Appendix C

Public Input

Summary of Public Input – 1st Round of Public Involvement – May 2012

FINAL DRAFT ETC Master Plan

Theme: Auto Mobility

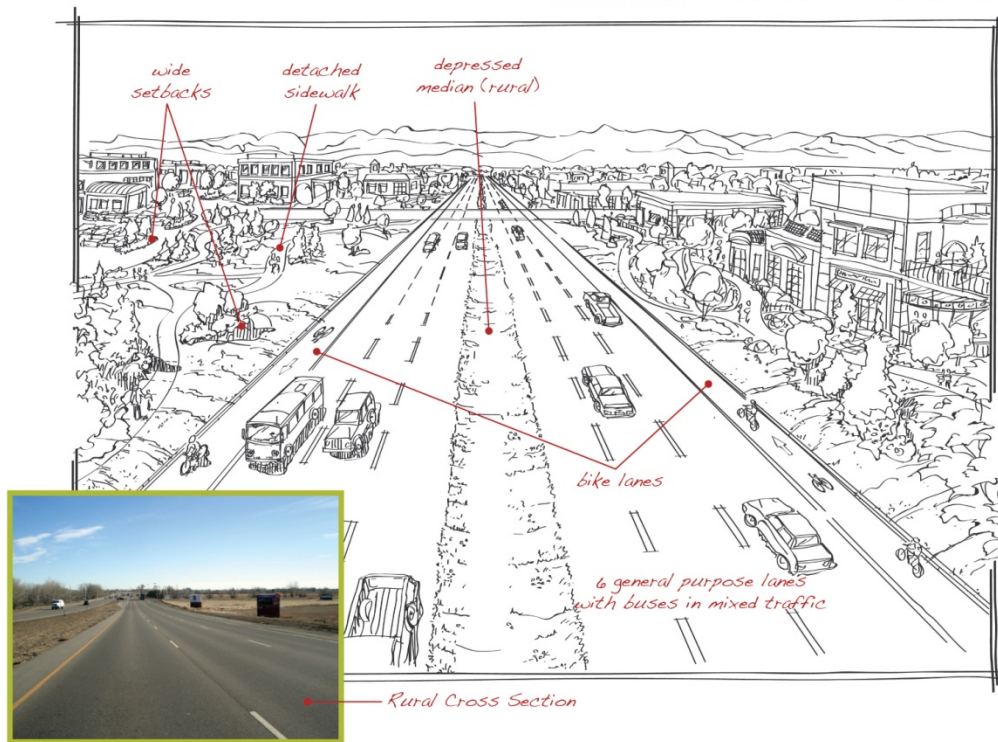
- ▶ Like the detached sidewalks – (22)
- ▶ Good for bikes – (19)
- ▶ Good for auto – (12)
- ▶ Like the wide setbacks – (7)
- ▶ Aesthetically pleasing – (6)
- ▶ Like 3 travel lanes on Harmony – (6)
- ▶ Each mode has its own space – (6)
- ▶ Like the green space – (2)

- ▶ Lane use appears understandable (user friendly) – (2)
- ▶ Like the access control – (2)
- ▶ Good for snow plowing – (1)
- ▶ Auto is predominant mode – embrace – (1)
- ▶ Realistic – (1)

- ▶ Too much emphasis on autos, freeway feel – (25)
- ▶ Unsafe for bicyclists (high speeds, too close to cars) – (24)
- ▶ Prefer separated bike lanes – (14)

- ▶ Unattractive (especially depressed median) – (10)
- ▶ Prefer a dedicated bus lane – (7)
- ▶ Concern about pedestrian/transit users ability to cross the street – (6)

- ▶ Not environmentally responsible/sustainable – (5)
- ▶ Regressive/Proven to be ineffective – (5)
- ▶ No “life” on the street, needs urban amenities, sense of community – (5)

- ▶ Not good for pedestrians, shopping/residential too separated – (5)
- ▶ Bikes should be routed to other streets – (4)
- ▶ Bikes should be moved to the sidewalk (shared use path) – (4)

- ▶ Unfair to non-drivers – (4)
- ▶ Poor business access – (3)
- ▶ Add landscaping in median – (2)
- ▶ Depressed median seems unsafe – (2)
- ▶ Encourages unhealthy mode of transportation – (1)

- ▶ Buildings set back too far – (1)
- ▶ Needs more dense land use to encourage other modes – (1)
- ▶ Concern about ROW impacts – (1)

Theme: Parkway with Enhanced Bus

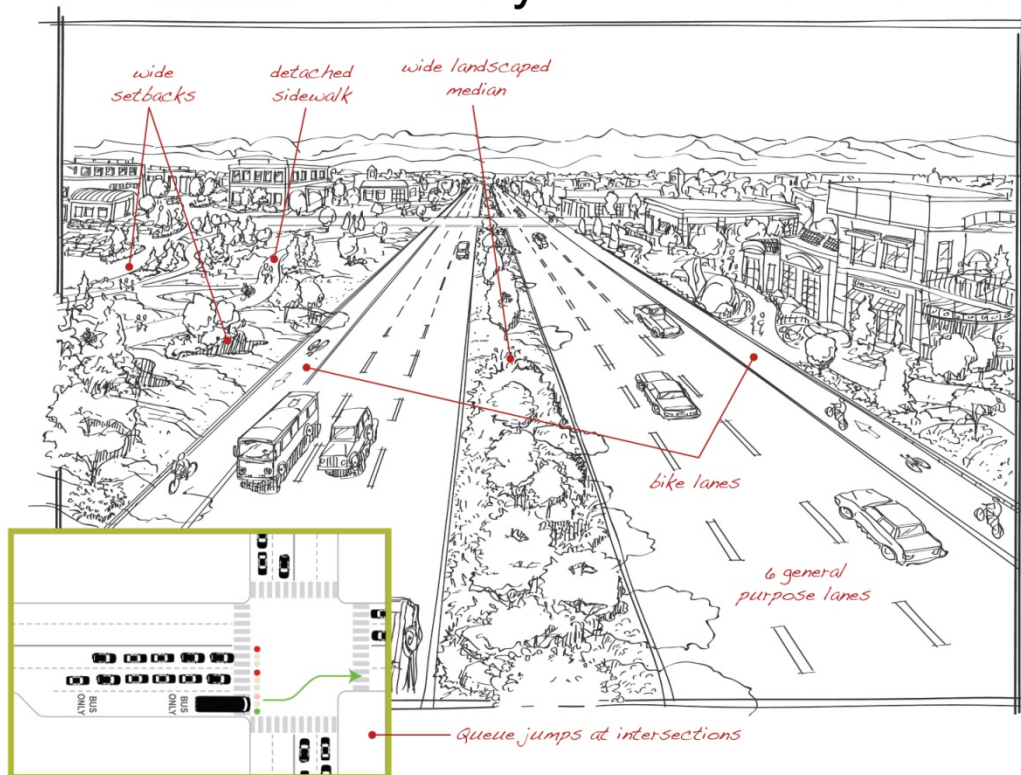
- ▶ Like the landscaped median – (42)
- ▶ Like the increased emphasis on bus – (17)
- ▶ Aesthetically pleasing – (14)
- ▶ Like the detached sidewalks – (12)
- ▶ Like the wide setbacks – (7)
- ▶ Like the dedicated bike lane – (6)
- ▶ Good for bikes – (6)

- ▶ Good for auto – (4)
- ▶ Friendly, vibrant – (3)
- ▶ Good for pedestrians – (2)
- ▶ Each mode has its own space – (1)

- ▶ Unsafe for bicyclists (high speeds, too close to cars) – (19)
- ▶ Too expensive to implement and maintain (especially landscape median) – (11)
- ▶ Prefer separated bike lanes – (9)

- ▶ Concern about pedestrians crossing wide intersections – (6)
- ▶ Visibility limited by over-landscaping – (6)
- ▶ Too much emphasis on autos – (5)
- ▶ Do not anticipate much bus ridership – (5)

- ▶ Too wide, too many lanes, too much traffic – (4)
- ▶ Not good for pedestrians (and transit users), shopping/residential too separated – (3)
- ▶ Dislike the bus's interference with traffic flow – (3)

- ▶ Need more bike and ped friendly facilities – (3)
- ▶ Wide median is wasted space – (3)
- ▶ Prefer dedicated bus lane – (3)
- ▶ Prefer grade separated pedestrian crossing – (3)

- ▶ Bus/bike conflict – (3)
- ▶ Difficult for bikes to turn left – (3)
- ▶ Higher densities needed to support transit – (2)
- ▶ Bikes should not be on Harmony – (2)

- ▶ Regressive – (1)
- ▶ Bus service is not as important as traffic flow – (1)
- ▶ Seems too crowded – (1)
- ▶ Raised median safer with 3 lanes – (1)
- ▶ Add green bike boxes – (1)

- ▶ Buses need designated pull outs – (1)

Theme: High Capacity

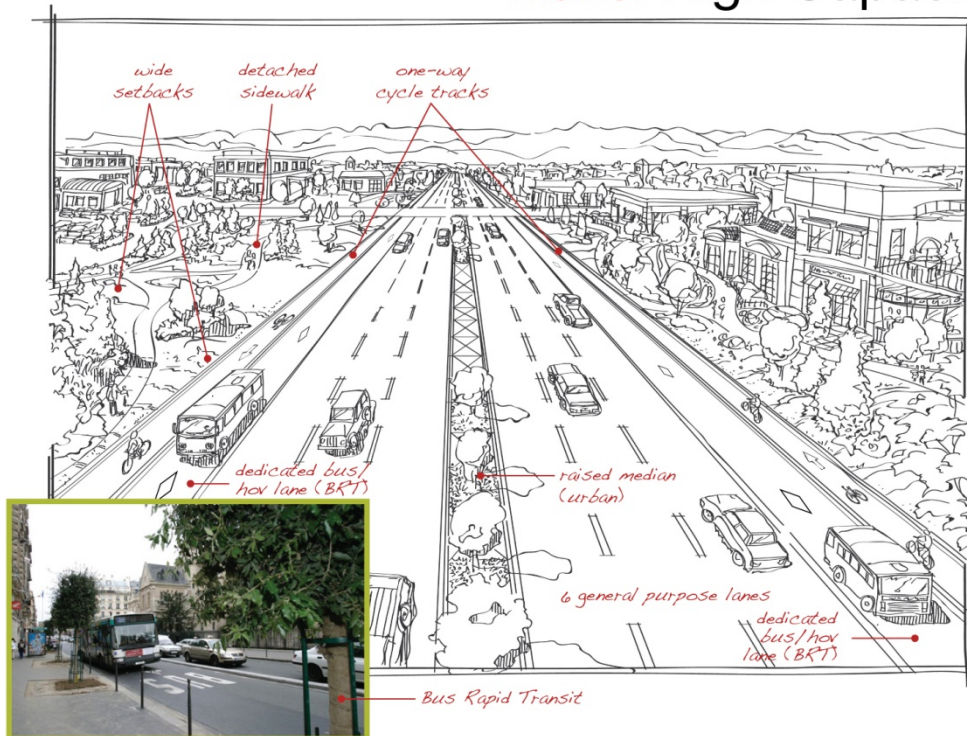
- ▶ Like the dedicated bus lanes – (41)
- ▶ Like the separated cycle tracks – (37)
- ▶ Supportive of all aspects/favorite – (13)
- ▶ Improves safety for cyclists – (11)
- ▶ Good multimodal options – (10)
- ▶ Like the detached sidewalks – (6)
- ▶ Like the landscaped median – (5)
- ▶ Like HOVs using bus lane – (4)

- ▶ Bus lane provides an extra buffer between cyclists and auto – (4)
- ▶ More environmentally friendly – (3)
- ▶ Like the less costly median – (2)
- ▶ Aesthetically pleasing – (2)

- ▶ Too wide, too much traffic – (21)
- ▶ Don't need separate bus lane/not justified – (13)
- ▶ Very difficult for pedestrians to cross – (11)
- ▶ Concern about bus/right turn conflict – (8)

- ▶ Concern about cycle track treatment at intersection – (7)
- ▶ Not aesthetically compelling – (7)
- ▶ Too much going on – (6)
- ▶ More protection needed for bikes – (4)

- ▶ Need grade separated bike/ped crossings – (3)
- ▶ Cycle tracks should be two-way – (3)
- ▶ Difficult for cyclists to make left turns – (3)
- ▶ Confusing for out of town visitors – (3)

- ▶ Bikes should not be on Harmony – (2)
- ▶ Expensive – (1)
- ▶ Concern about bus signal priority and driver confusion – (1)
- ▶ If HOV, bus stop/HOV conflict – (1)

- ▶ Don't support use of City funds for bike/bus – (1)
- ▶ Bus pull outs from GP lanes instead – (1)
- ▶ Not human friendly – (1)
- ▶ Would like to see roundabouts – (1)

- ▶ Over-designed – (1)
- ▶ No improvement over existing – (1)
- ▶ Concern about ROW impacts – (1)
- ▶ Don't need 6 lanes with separate bus lane – (1)
- ▶ Dislike raised median – (1)

Theme: Active Urban Corridor

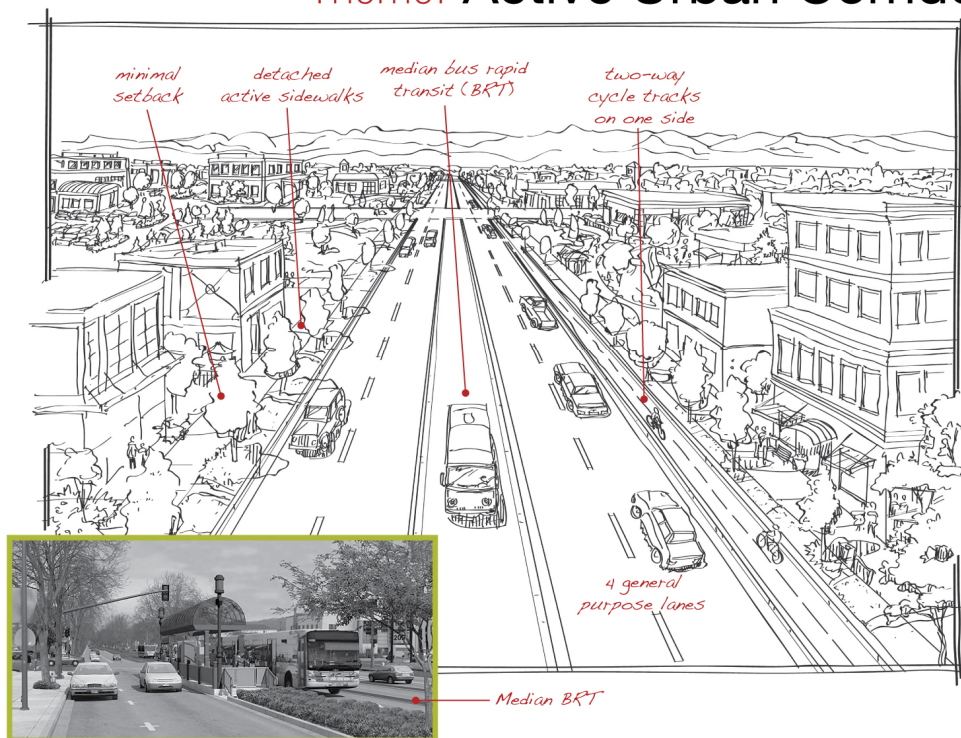
- ▶ Like the median BRT – (18)
- ▶ Supportive of all aspects/favorite – (17)
- ▶ Like the downtown/community feel/minimal setback – (9)
- ▶ Encourages alternative travel modes – (8)
- ▶ Like the two-way cycle track – (8)
- ▶ Like the bikes being separated from traffic – (7)
- ▶ Improves safety for cyclists – (6)
- ▶ Good multimodal options – (5)

- ▶ Pedestrian friendly – (5)
- ▶ Like having only 4 auto lanes – (4)
- ▶ Like that it is less of an “asphalt jungle” – (3)
- ▶ Traffic speeds would be slow (favorable) – (3)
- ▶ Looks efficient/compact – (3)
- ▶ Better for businesses – (2)
- ▶ Would serve commuters well – (1)
- ▶ More environmentally friendly – (1)

- ▶ Lacks needed auto capacity – (35)
- ▶ Too cramped/too urban/big city – (16)
- ▶ Bikes should be on both sides – (16)
- ▶ Buildings too close to road – (16)

- ▶ Too congested – (15)
- ▶ Concern about how pedestrians would cross from station – (15)
- ▶ Dislike the two-way cycle track – (11)
- ▶ Not appropriate for Harmony – (6)

- ▶ Not aesthetically compelling/no median landscaping – (4)
- ▶ Concern for safety on two-way cycle track (esp at intersections and accesses) – (3)
- ▶ Pedestrians too close to street, unpleasant – (3)

- ▶ Concern median BRT would require more signals – (3)
- ▶ Need grade separated bike/ped crossings – (3)
- ▶ Too much emphasis on bus – (3)
- ▶ Concern about buses passing each other – (2)

- ▶ Dislike the bus in the median – (1)
- ▶ No room for expansion – (1)
- ▶ Concern about snow storage – (1)
- ▶ Concern about safety for left turners – (1)

- ▶ Don't need separate bus lane/not justified – (1)
- ▶ Median BRT would confuse drivers – (1)
- ▶ Don't support use of City funds for bike/bus – (1)
